Project Title: kirkpatrick Building Permit #: _____ City Drainage #: C17D122
DRB#: _____ EPC#: _____ Work Order#: _____
Legal Description: B1A5 CLIFFORD INDUSTRIAL PARK
City Address: 8610 presidents place

**RE: Revised Grading Plan (C-17D122)
Kirkpatrick Warehouse
Albuquerque, New Mexico**

**Re: Kirkpatrick Warehouse
Kirkpatrick Warehouse Drainage Report with Engineer's Stamp dated 11-25-14
Kirkpatrick Grading and Drainage Plan with Engineer's Stamp Dated 12-22-14
(C17D122)**

ACCEPTABLE FILL MATERIALS: STORMTECH DC-780 CHAMBER SYSTEMS

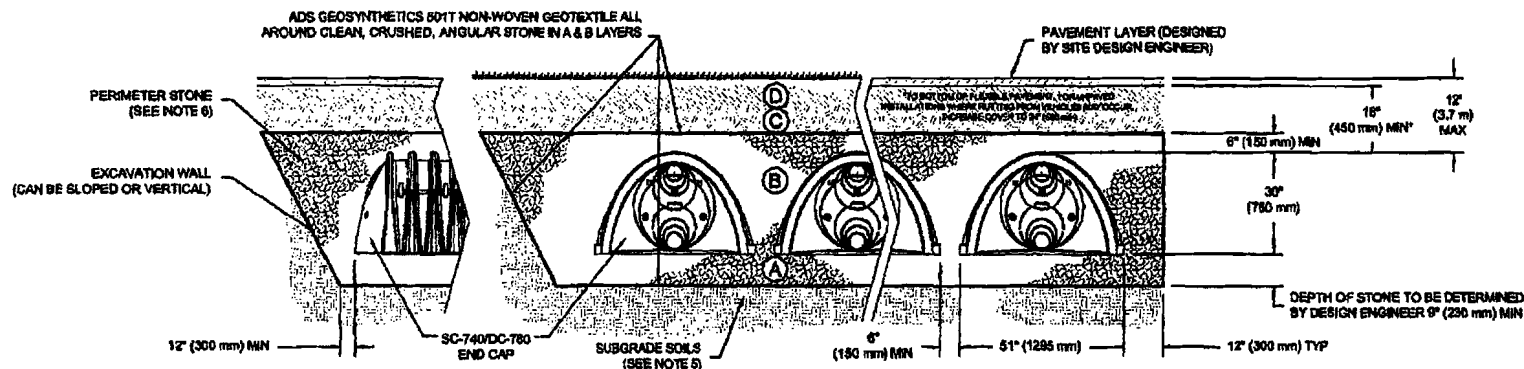
6. What are the depths and type of stone for system

7. what kind of geo textile is used and where is it located

The standard detail shows 9" below, 6" above and 12" on side. The type of stone is on the detail sheet.

The location and type of geotextile is shown on the detail sheet.

DC-780 INSPECTION PORT DETAIL
NTS

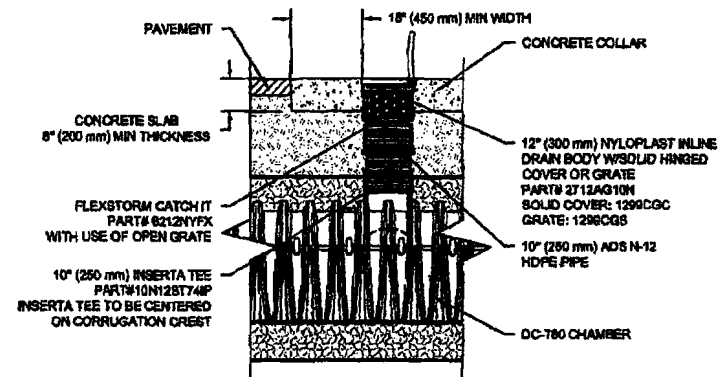
4. Specify manifold, and separation, how is system to be cleaned

We have better shown how the manifold works, the inlet is an inline basin each leg of the inlet drains to a reach of the system. The details show the separation of 6". We have added inspection ports which are used for maintenance. A vactor truck is used for periodic maintenance.

ENGINEER'S SEAL  12/22/14 DAVID SOULE P.E. #14522	TRACT B-1-A-5 CLIFFORD INDUSTRIAL PARK	DRAWN BY JDG
	GRADING AND DRAINAGE PLAN	DATE 11-26-2014
 Rio Grande Engineering 1606 CENTRAL AVENUE SE SUITE 201 ALBUQUERQUE, NM 87106 (505) 872-0999	SHEET # 1 OF 1	JOB #

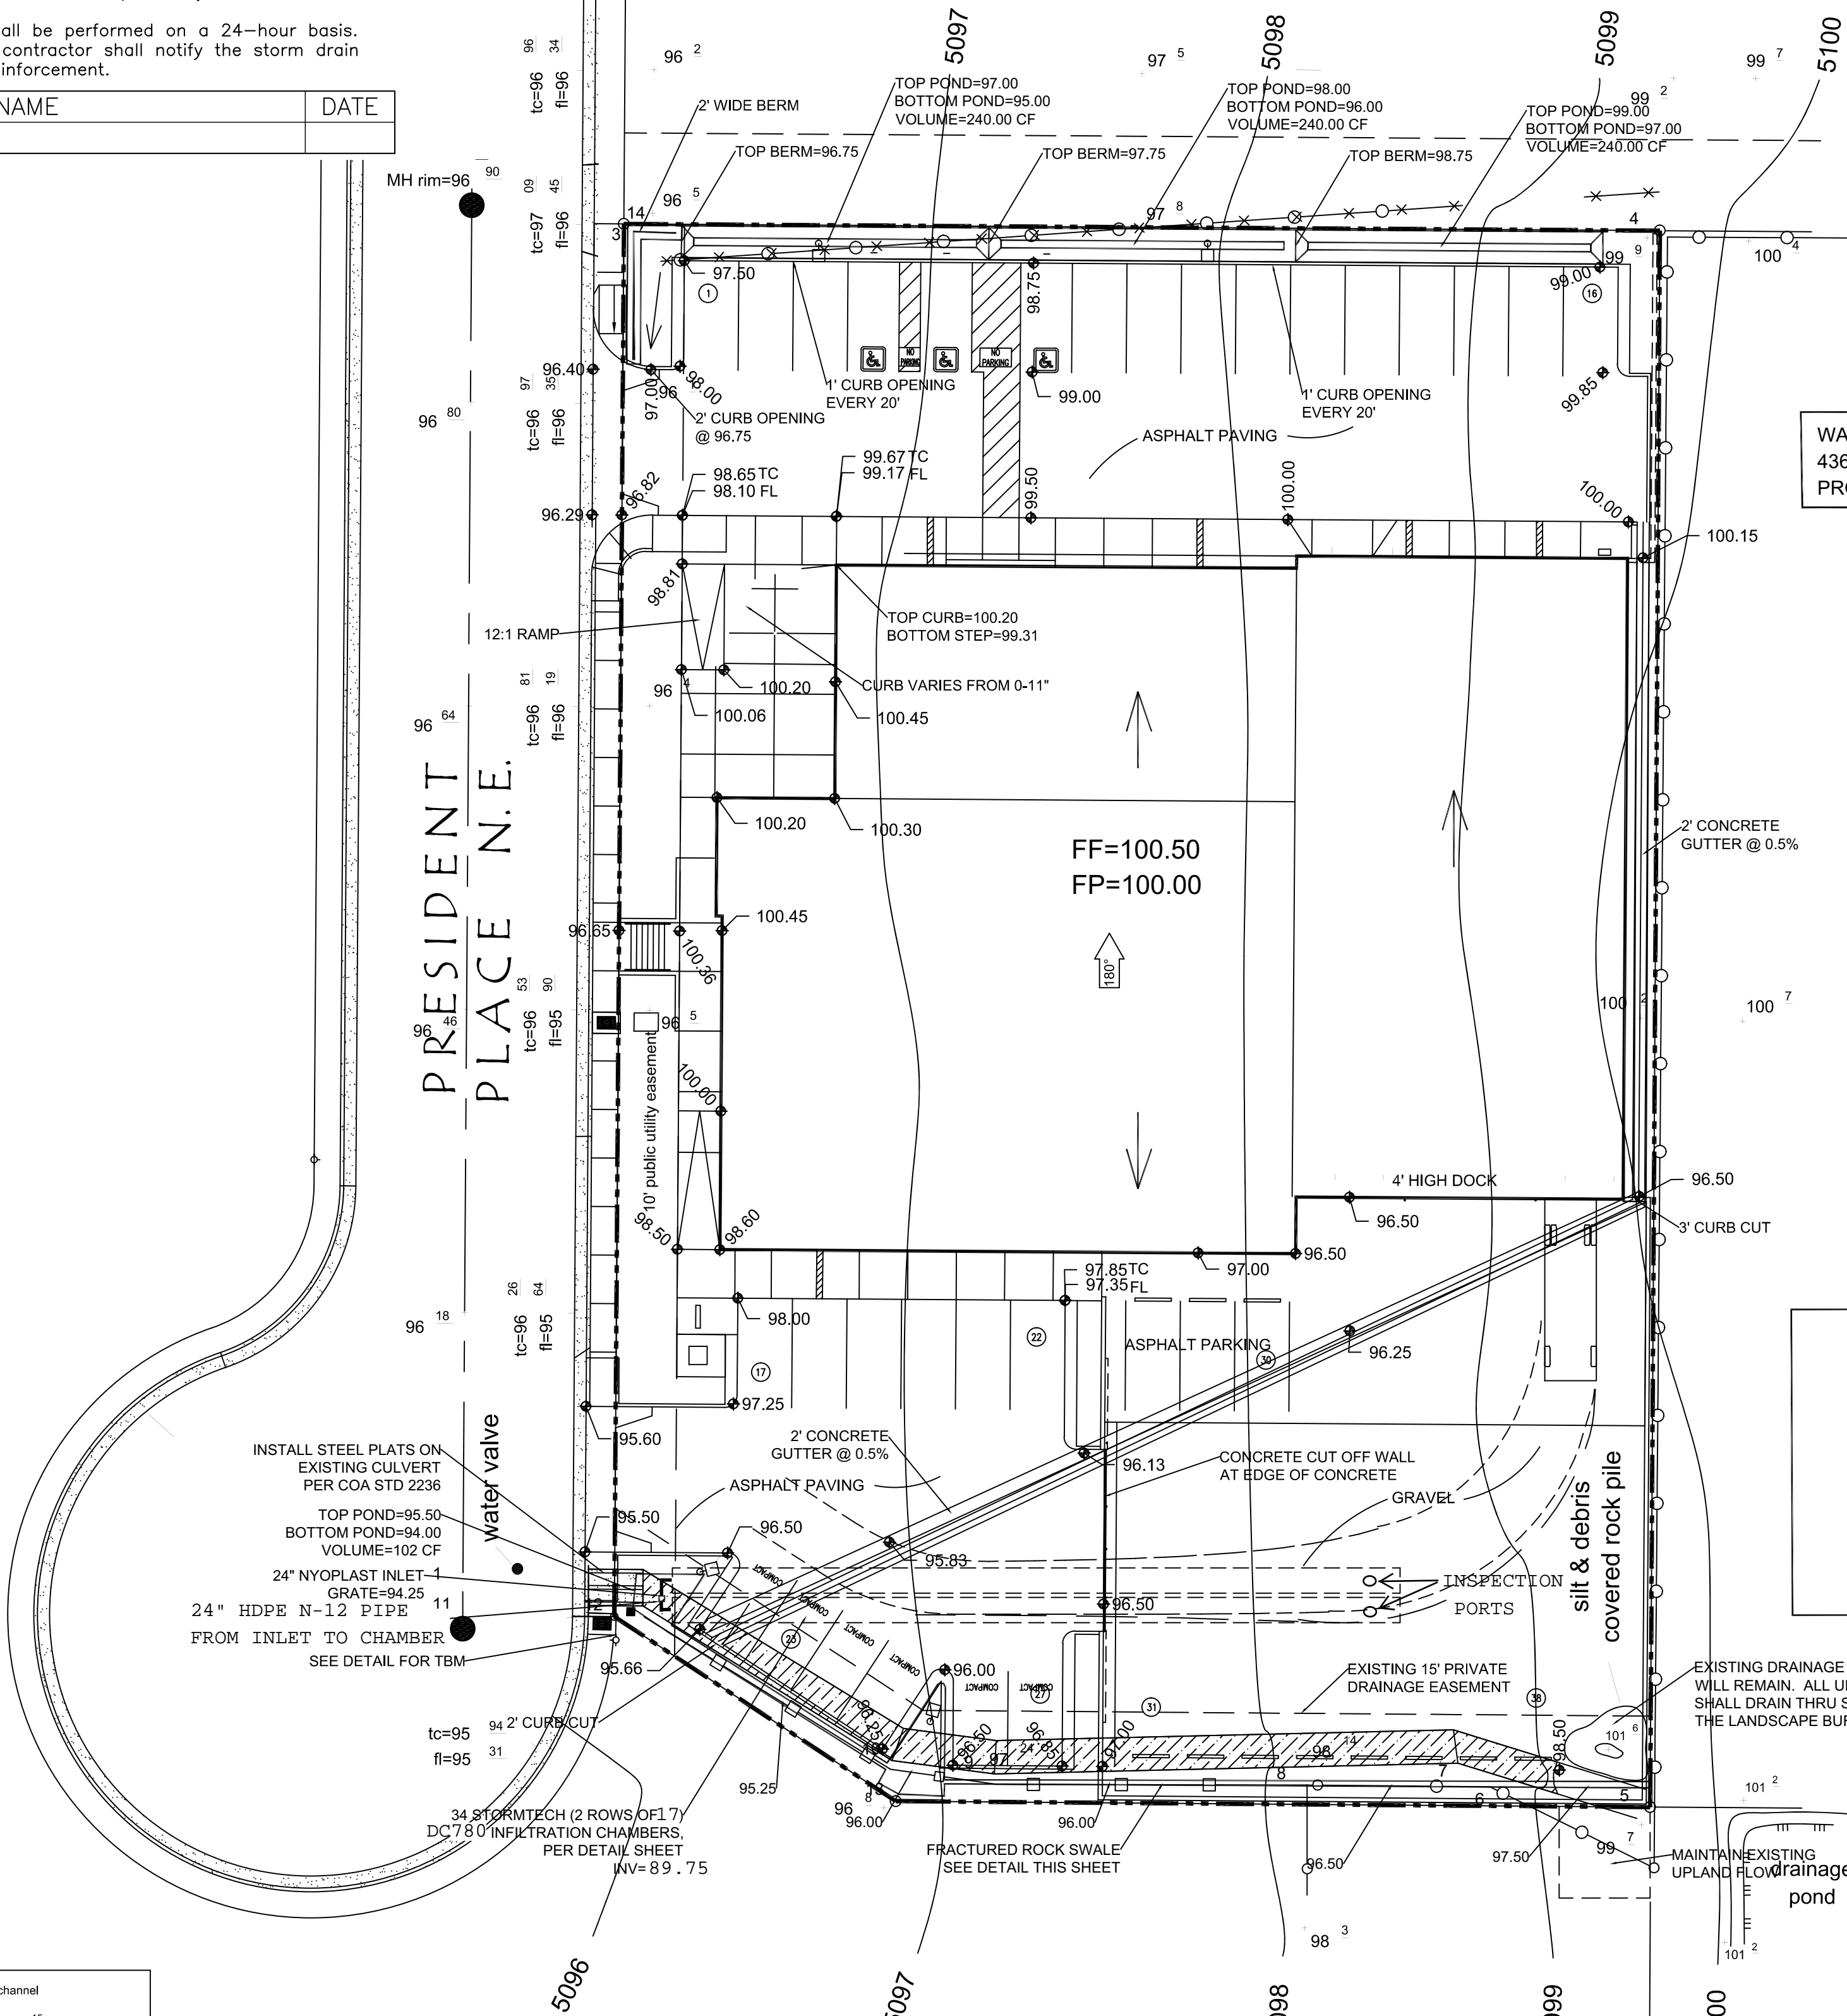
1. Provide calculations for storm tech.

3. Correct typo on invert.

I have highlighted the volume for each chamber (78.4 cf) the drainage calculation sheet show division of the required volume of $2677/78.4 = 34$ chambers

We have corrected the typo.
